# SCH STAGE 1 / CCCC

## PUBLIC DOMAIN & LANDSCAPE

### RESPONSE TO SUBMISSIONS REPORT

SSD-10831778  
14 September 2021  
APPENDIX No. 01

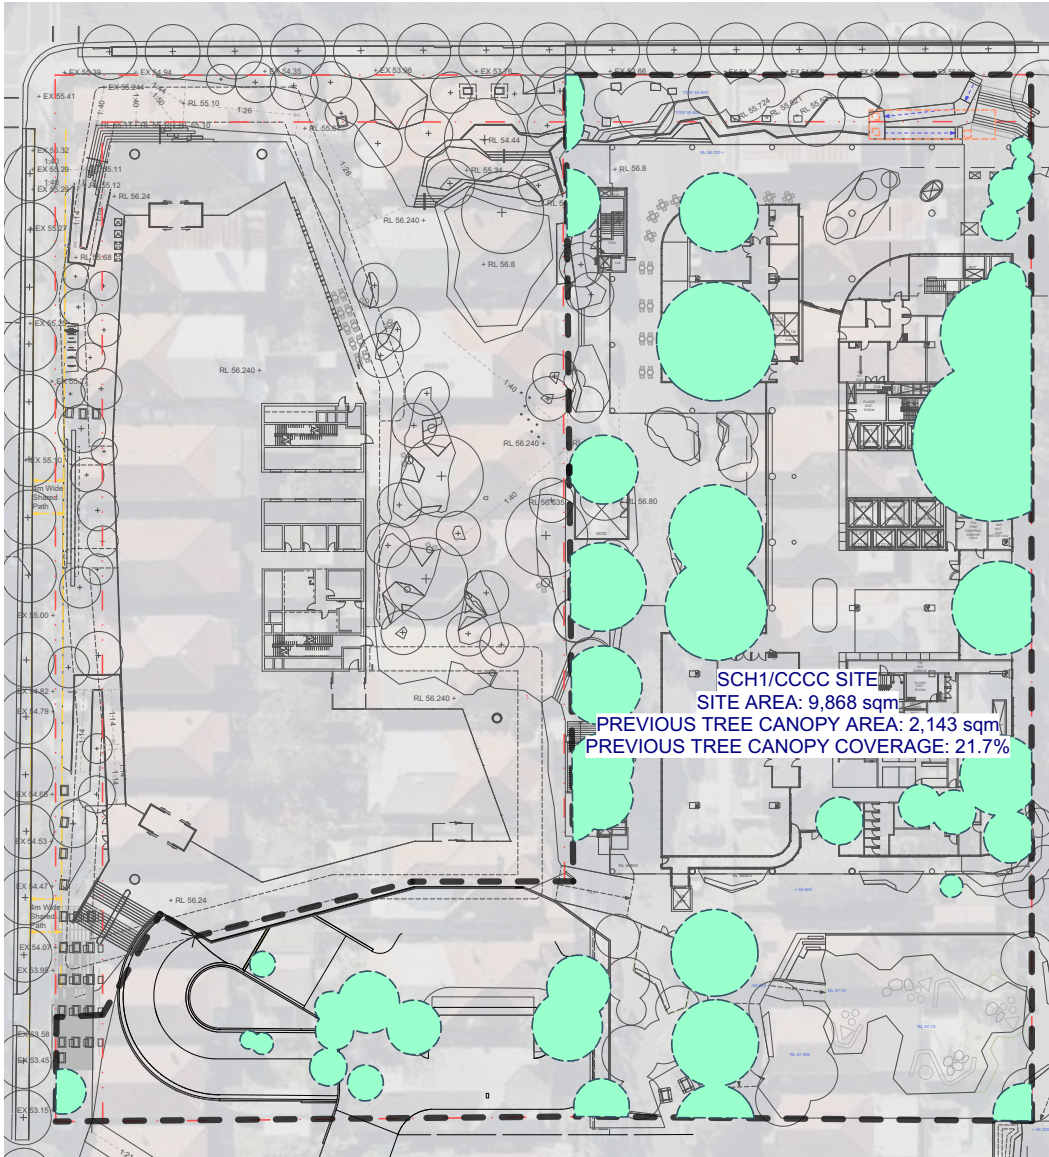
Consideration should be given to improving tree canopy cover, noting the proposal falls short of minimum 25 per cent recommended within the NSW Government Architect’s Draft Greener Places Design Guide. Any comparisons against the ‘existing’ canopy coverage to justify the proposed canopy cover should be based on an assessment of the canopy cover of the previous residential use of the site, prior to clearing of the site. Consideration should be given to opportunities to providing more or larger trees at the ground plane through improved soil depth and volumes for on-structure plantings and through more detailed consideration of opportunities and limitations of plantings above and around the stormwater culvert.

The design for the public realm and landscape for the SCH1/CCCC has been shaped through a series of precinct-wide principles, developed with the adjacent project teams of IASB and UNSW HTH. These have created an urban outcome that is safe, permeable and legible, culturally-significant, comfortable and engaging, and driven by the users of the place.

The design team has also worked closely with the client and architectural teams to understand the building programming constraints, particularly regarding the requirements of the B1 level emergency department and ambulance bay. This has lead to significant challenges in providing required soil volumes and set downs to meet the 25% requirement of tree canopy coverage. This coupled with existing underground stormwater constraints has lead to the landscape outcomes of a maximum possible canopy coverage of 15.5% within the site whilst also balancing the key precinct principle of maintaining clear, open and intuitive wayfinding.

Proposed Canopy Cover

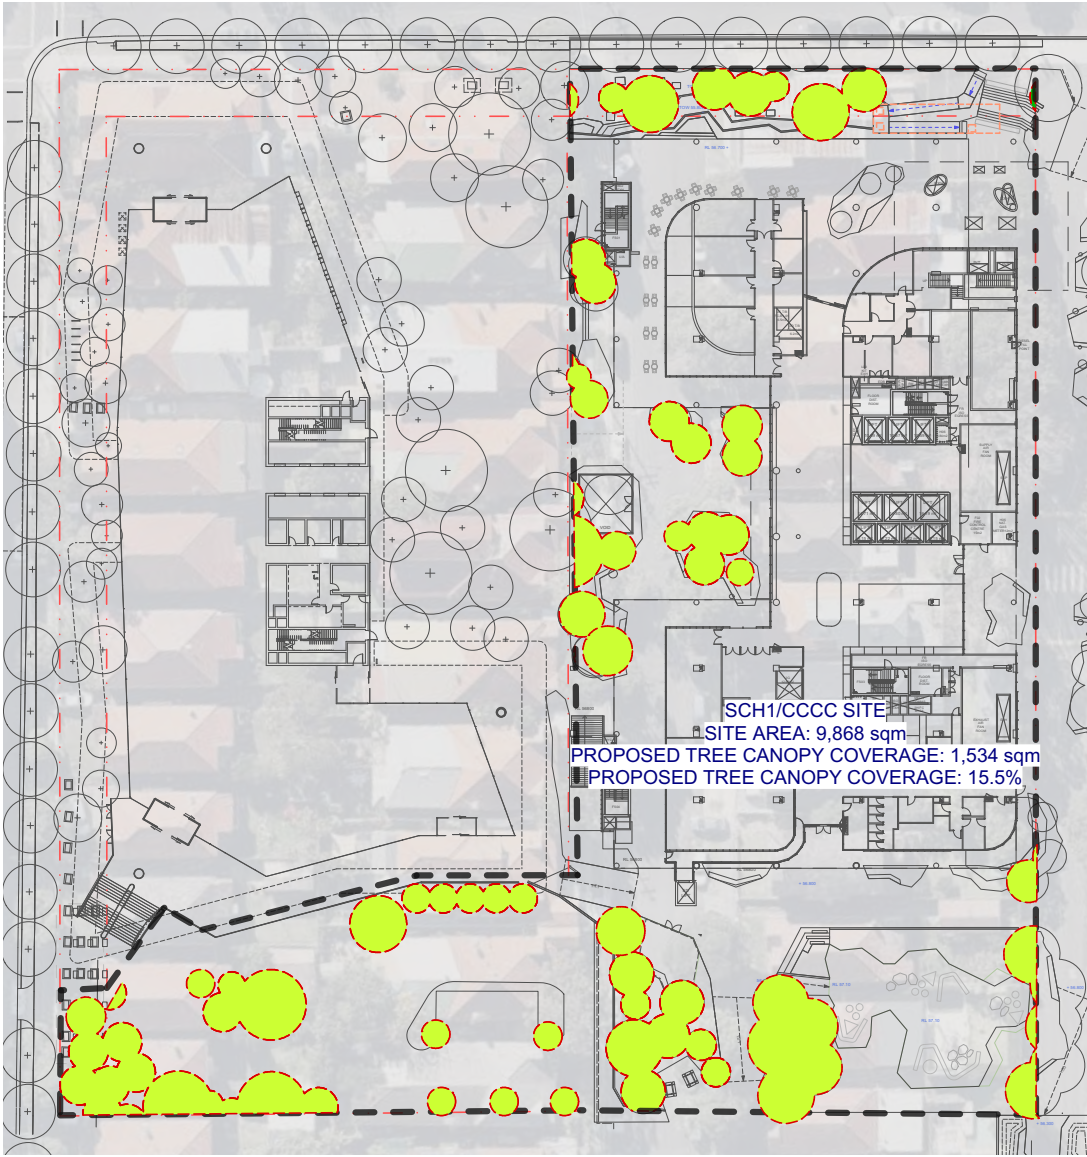
It is noted that the proposal includes a 15.5 percent site canopy cover. This canopy target is well below the minimum 25 percent tree canopy cover outlined in the Urban Tree Canopy Guide within the NSW Government Architect’s Draft Greener Places Design Guide. The Draft Design Guide is recommended for use by State and Local Governments and industry to increase tree canopy across Greater Sydney. The proposed site canopy cover should be increased.

The design team has undertaken a review of the tree calculation including increasing the tree canopy coverage. The site is constrained due to the building footprint and basement below, limiting the ability to increase tree canopy coverage whilst maintaining pedestrian paths, clear and intuitive wayfinding, and building egress.

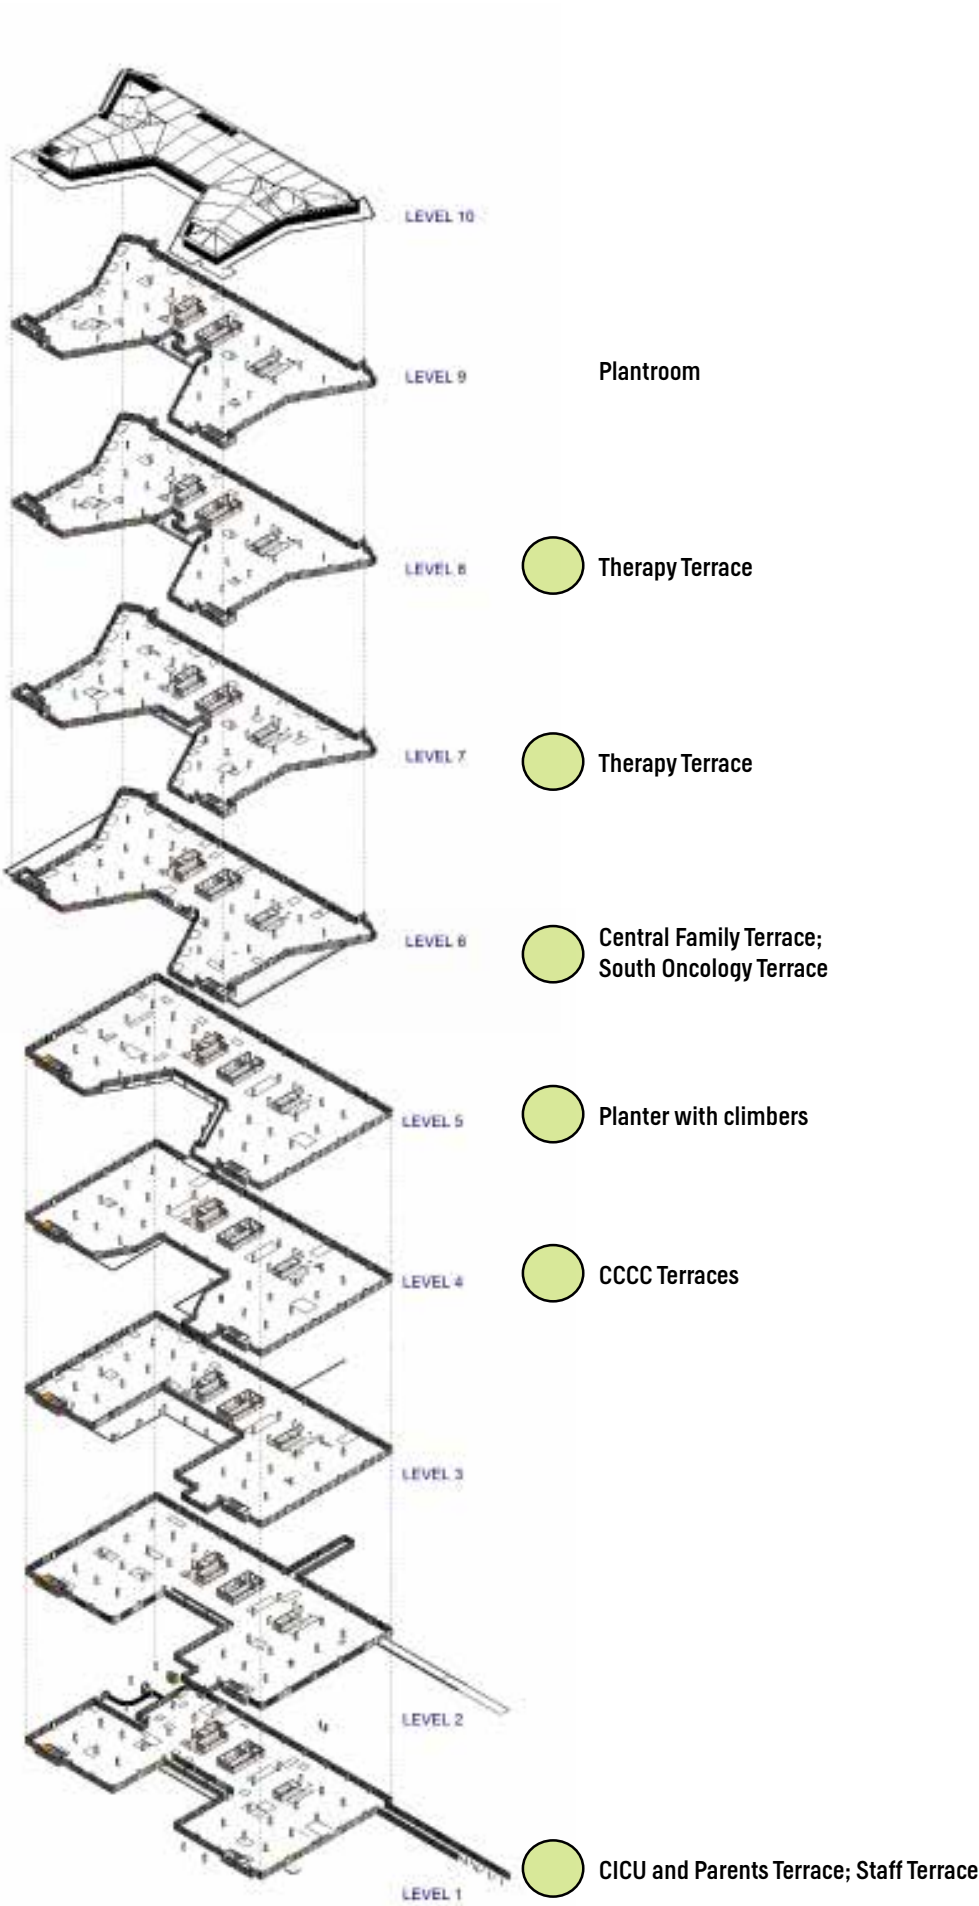
Visualisations indicate landscaping to upper levels terraces and utilisation of podium roof areas for landscaping but no details are provided on the landscape plans. Landscape plans should be updated to include these areas and demonstrate provision of high quality outdoor spaces for occupants of the building and to assist with offsetting any shortfall in tree canopy cover.

Further landscape detail is required for the proposed roof level and upper level terraces as the building form steps back. The podium roof areas should be utilised to provide outdoor landscaped terraces areas for patients, visitors and workers where possible.

The design team has included additional reference to the upper level terraces for levels 1, 4, 5, 6, 7, & 8, including the landscape plans as part of the updated landscape drawings. These series of accessible and inaccessible landscape spaces provides opportunities for patients, staff and visitors to experience the biophilic benefits of being in contact with plants and natural systems on a day-to-day basis.

This also includes a developed facade planter approach between levels 5 & 8 to create a green outlook both from within the buildings and viewlines from the public plaza.

The design team has updated the outdoor terraces to illustrate extent and use of these spaces. This includes a series of accessible and inaccessible spaces that allow for patient, staff, and visitor respite, engagement and enjoyment and will be developed further during DD stage.

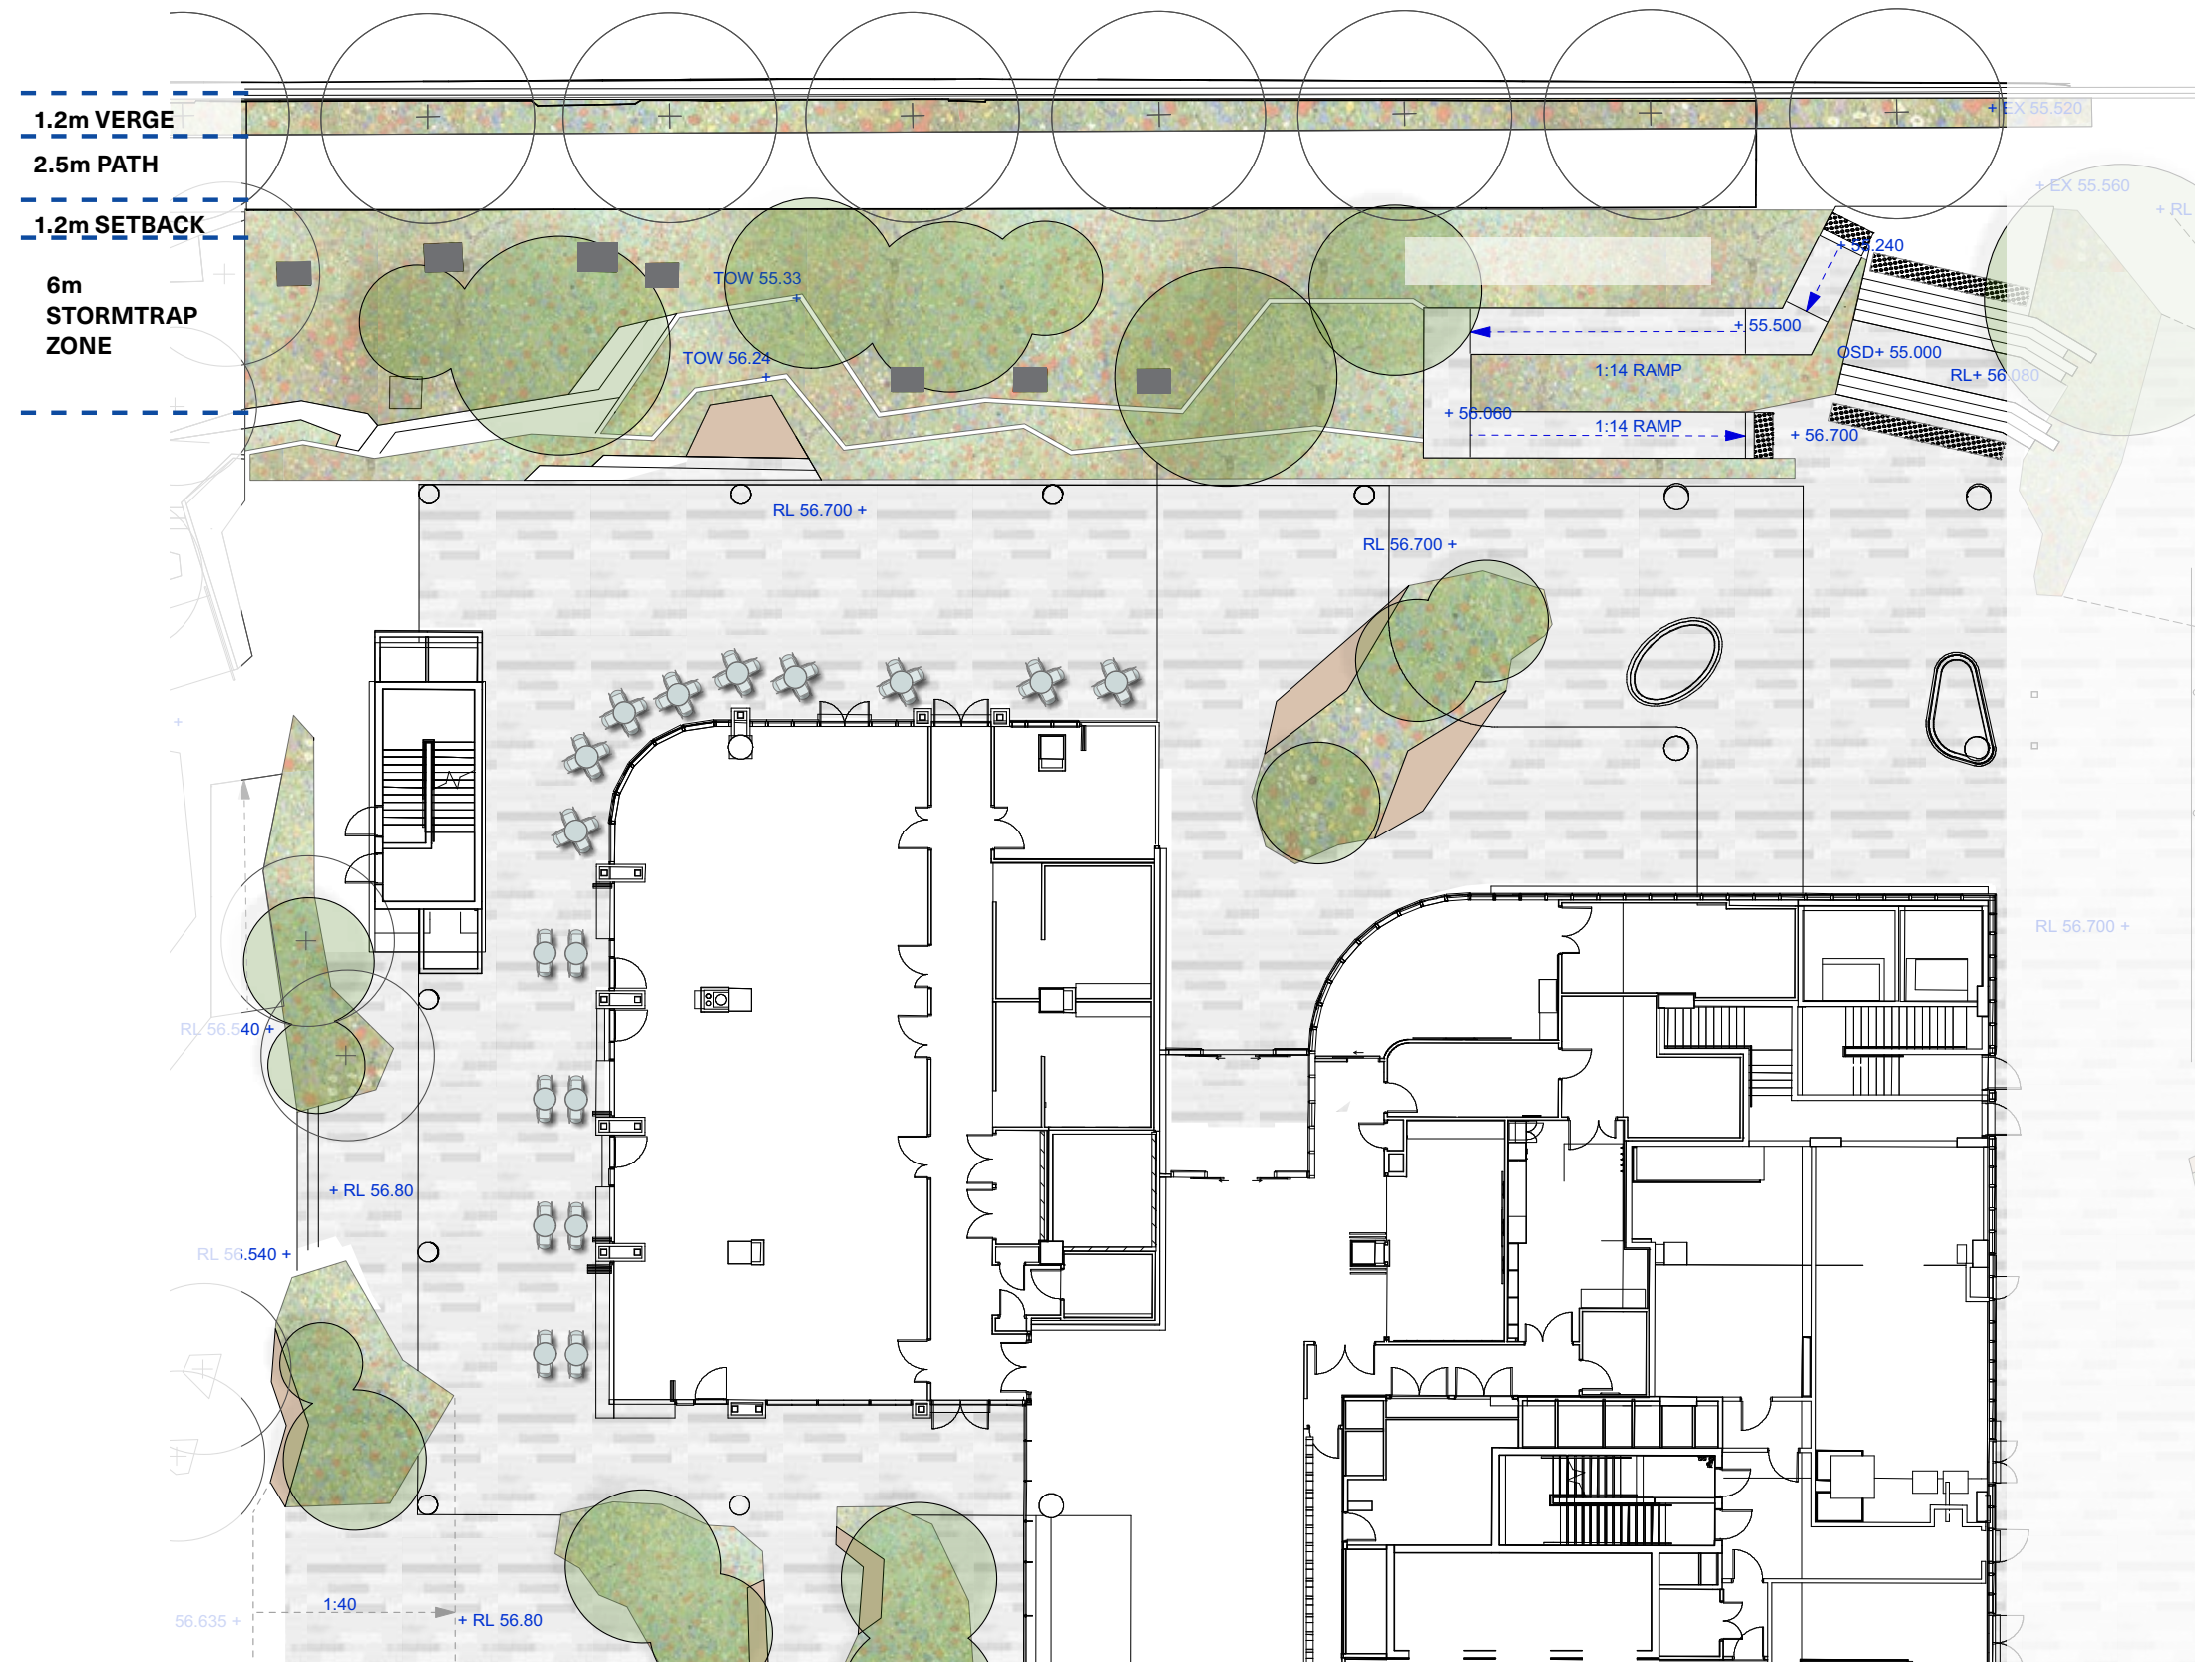
Consideration should be given to the design and layout of the landscaped area to the south of the building to create a more legible and direct east-west pedestrian connection between Hospital Road and Botany Street having regard to the alignment of the connection on the HTH site.

The proposed plans provide a constrained, confusing, and poorly articulated podium-level east-west route from the Botany Street footpath via the UNSW HTH building south podium to the Hospital Road shared path. It is recommended that the generous width connection proposed along the south edge of the UNSW HTH building is continued to ensure a direct and seamless connection to deliver a coordinated pedestrian route from Botany Street through to Hospital Road, and in the future, continuing east through the RHC.

The east-west connection has been reviewed as part of the precinct-wide strategy and the landscape approach has been revised to include a min. 5m DDA-compliant and accessible pedestrian path from Hospital Rd, to the stairs and ramp on the HTH site.

The design team has reviewed the design to ensure a generous east-west connection is provided. This was investigated at both the southern and northern existing connection between Hospital Rd and Botany St. A 5m wide path has been created to the south of the SCH1/CCCC building, and the landscape shaped to ensure viewlines from the existing Ainsworth Building to the HTH are clear and open. This new connection provides a DDA-compliant path that is also separated from vehicular movements.
